# Access Compliance Report Public Rights-of-Way (Curb Ramps)

Main Street: KITTRICK\_DR Cross Street: BASKERVILLE\_RD Location: N

ADA ID: RPAT211202090709 Ramp Type: Type 1 - Perpendicular Diagonal Initial Pass/Fail: Fail Overall Compliance: No Severity Score: 5

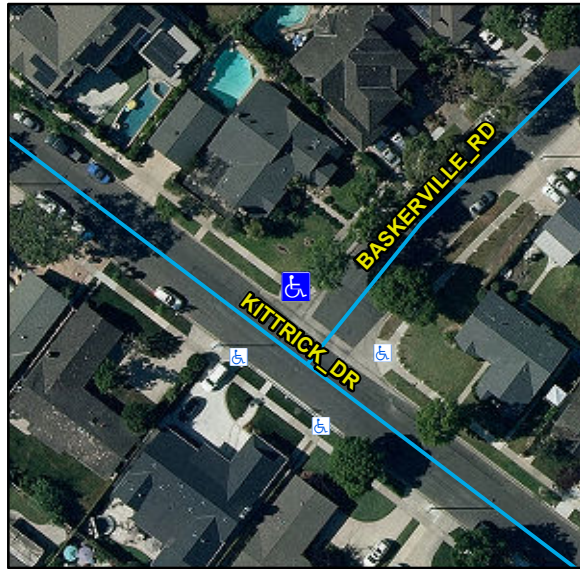
| Compliance | Description                           | Data | Compliance | Description                   | Data |
|------------|---------------------------------------|------|------------|-------------------------------|------|
| No         | Ramp Width (in)                       | 46   |            |                               | N/A  |
| No         | Ramp Cross Slope (%)                  | 2.3  | N/A        | Flare Traversable LT          | N/A  |

Remove & Replace Curb Ramp With Two New Directional Ramps or Equivalent.
